APPLICATION NO.	FILING DATE	FIRST NAMED INVENTOR	ATTORNEY DOCKET NO.	CONFIRMATION NO.
10/089,505	08/27/2002	Jean Rousseau	REGMI-013	9497
530	7590	07/28/2004	EXAMINER	
LERNER, DAVID, LITTENBERG, KRUMHOLZ & MENTLIK 600 SOUTH AVENUE WEST WESTFIELD, NJ 07090			BEISNER, WILLIAM H	
			ART UNIT	PAPER NUMBER
			1744

Office Action Summary	Application No. 10/089,505	Applicant(s) ROUSSEAU ET AL.	
	Examiner William H. Beisner	Art Unit 1744

5. Claims 1, 3 and 5-11 are rejected under 35 U.S.C. 103(a) as being unpatentable over McCurdy (US 3,450,389) in view of Cribb et al.(US 4,948,440).

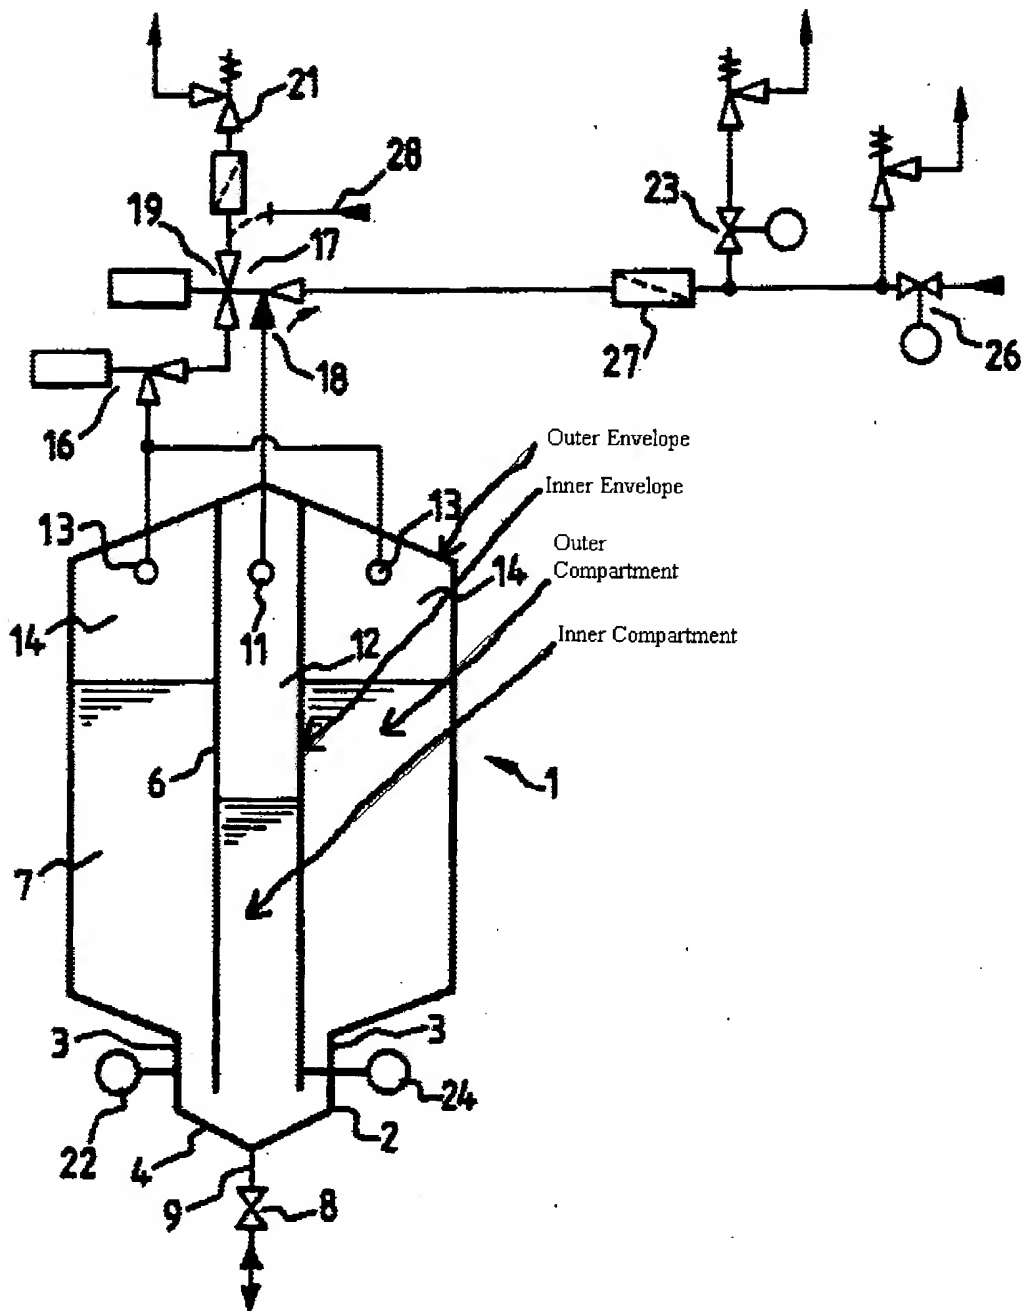
6. Claims 1, 3 and 5-11 are rejected under 35 U.S.C. 103(a) as being unpatentable over Sillett (US 5,005,472) in view of Nelson (US 3,678,955).

The reference of Sillett discloses a reactor device or mixing device (1) that includes an outer envelope, an inner envelope, an inner compartment and an outer compartment (See Figure Below). The envelopes and/or compartments are sealed relative to the external environment and communicate with one another "mainly" in the bottom of the compartments. The device also includes means for injecting pressurized gas (11) into the inner compartment and means for removing directly pressurized gas (13) from the outer compartment.

Claim 1 differs because the claim recites that the envelopes are made of plastic while the primary reference of Sillett is silent as to the material of construction of the reactor structures.

With respect to claims 5 and 6, the reference of Sillett discloses the use of nozzles (11 and 13).

With respect to claim 8 and 9, the reference of Sillett discloses the use of tube (9) that communicates with the bottom of the outer compartment. Note statements of intended use carry no patentable weight in apparatus-type claims when the structures elements are structurally capable of providing the intended use or function.
